To	Laura Oliver, Deputy Recorder
From	Shay Stark, Contract City Planner
Date	October 30, 2019
CC	
Subject	C & L Estates Subdivision Preliminary Plan – Planning Commission Memo

To	Laura Oliver, Deputy Recorder
From	Shay Stark, Contract City Planner
Date	~~August 13, 2019~~ 2nd Review October 30, 2019
CC	
Subject	C & L Estates Subdivision Preliminary Plan – 2nd Review

C & L ESTATES

Preliminary Plan Second Submittal Review Comments.

SHEET NO. 2

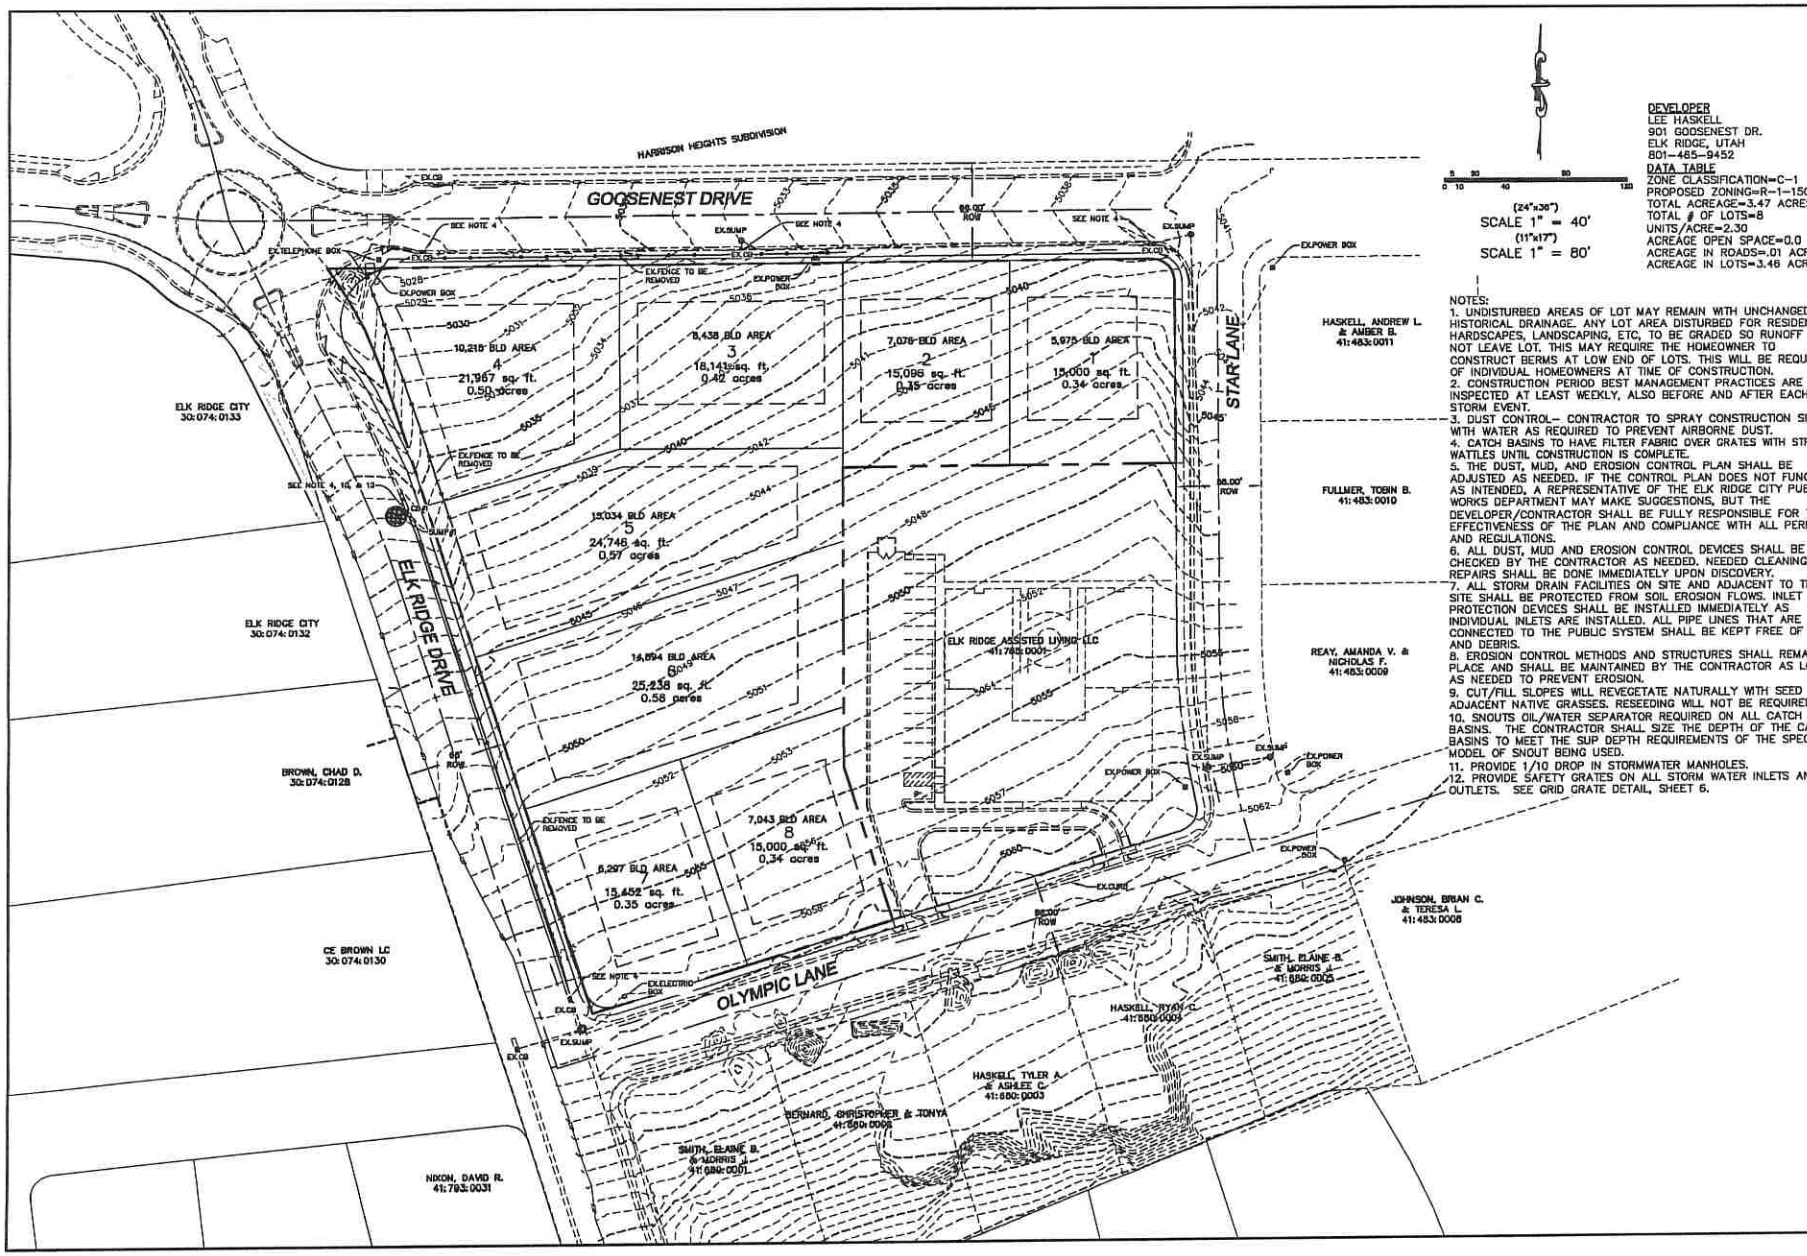
- (Sheet 2) Run a closure report to verify closure.
- (Sheet 2) Dimension and label setbacks and PUE's or provide reference to detail with this information.
- (Sheet 2) Add dimensional units (ex. (x') foot marking) to curve table dimensions.
- (Sheet 2) Expand Acreage units for dedications parcels "A" & "B" to four decimal places to capture the acreage amounts.

SHEET NO. 3

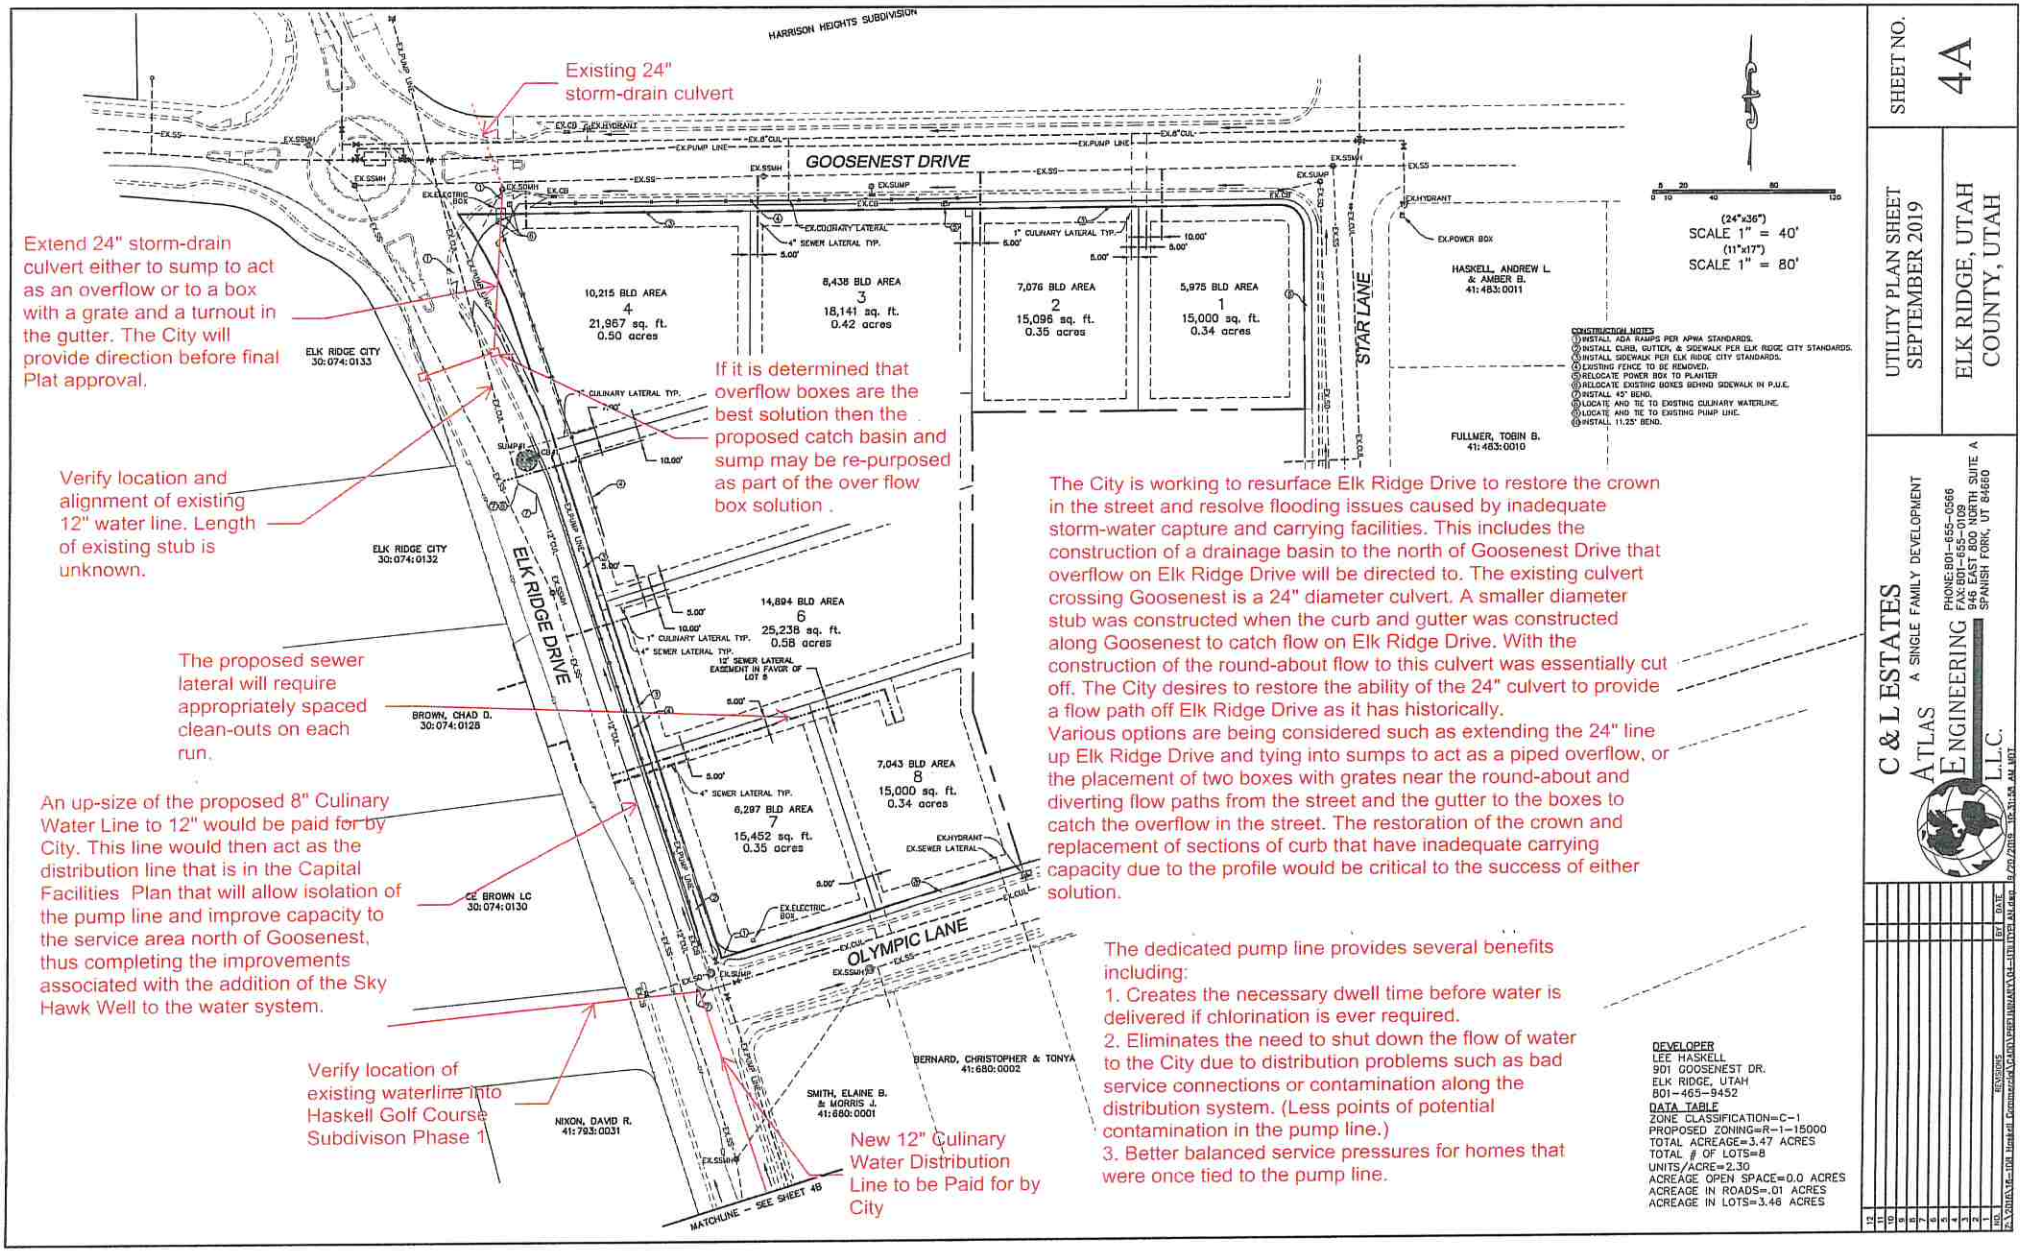
- (Sheet 3) Note #9 states: Cut/Fill slopes will revegetate naturally with seed from adjacent native grasses. Reseeding will not be required. Will the City require reseeding of disturbed areas?

SHEET NO. 4B

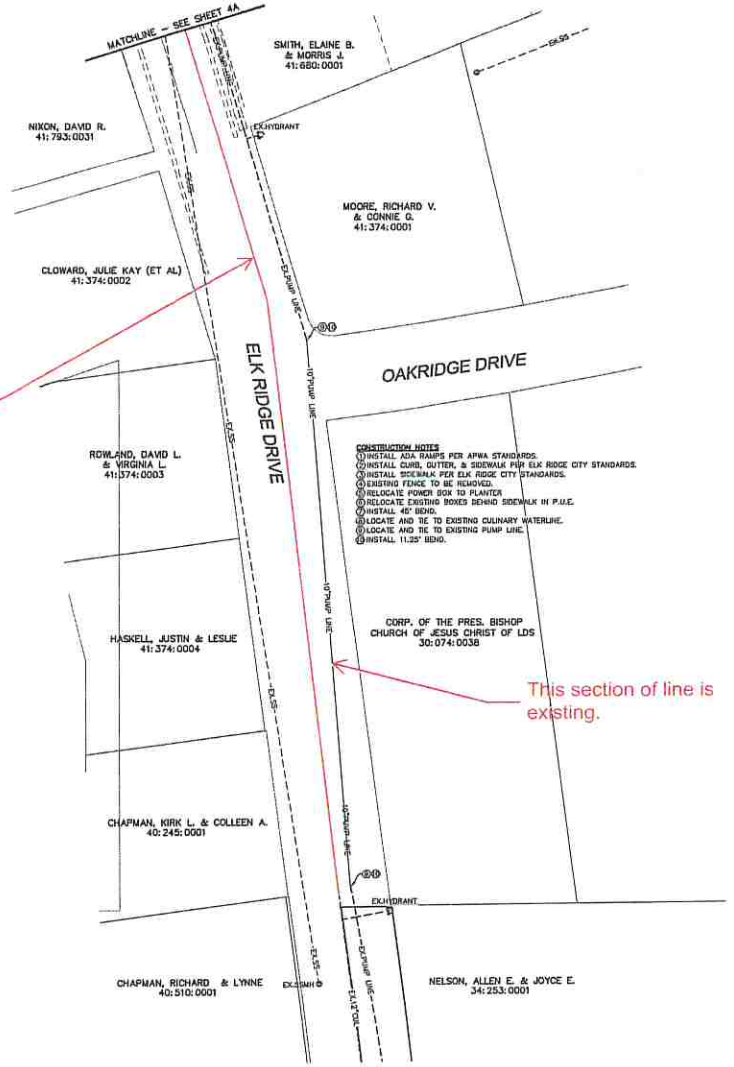
New 12" distribution line to be paid for by the City. The new line would also include relocation of the remaining services off the existing pump line to the new line and relocation of fire hydrants off the pump line to the new line. The services and hydrants requiring relocation need to be determined by the City. There may be services on Elk Ridge Drive and Goosenest Drive that require relocation.

SHEET NO. 6

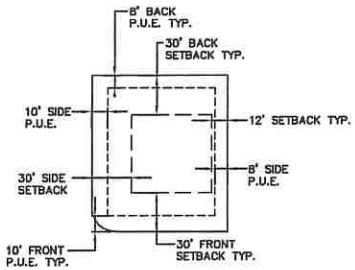
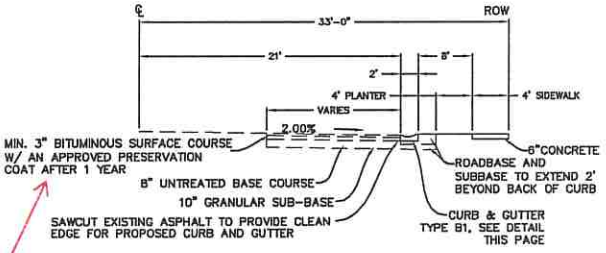
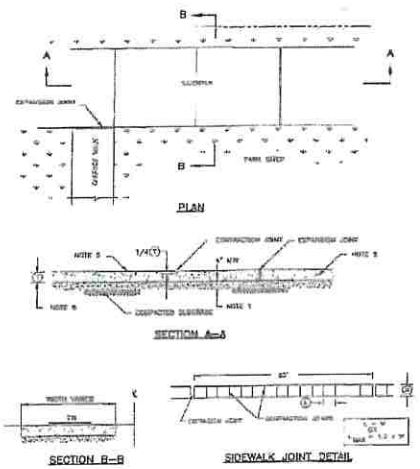
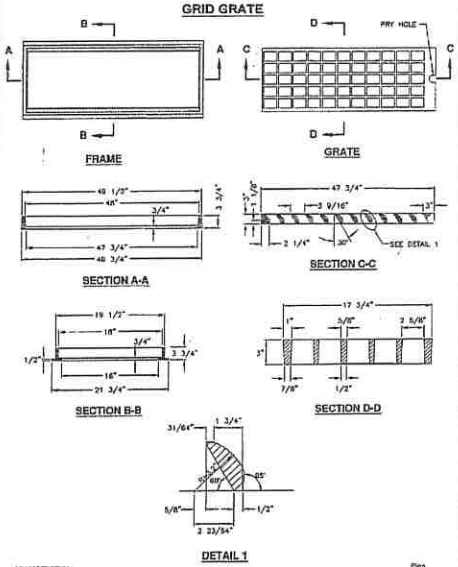
- (Sheet 6) Update street cross section detail to match the cross section used for the Parkview Corner Subdivision (see attached).

The City requires a 1" surface course overlay from crown to gutter on existing boundary streets where cuts and patches or additional pavement width are required. With the potential resurfacing of Elk Ridge Drive this will need to be discussed as construction drawings are created.

SHEET NO. 7

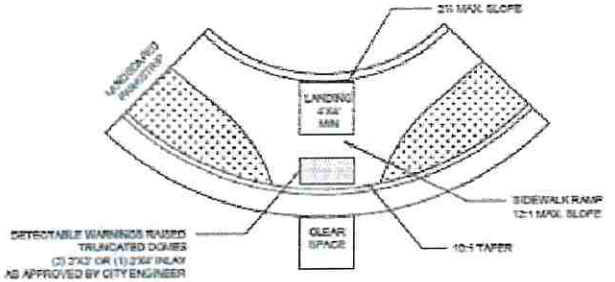
The details on this sheet don't print out very clear.

The applicable State approved City standard water details will be required as part of the construction drawing package.

APWA trench and patching details will also be required.
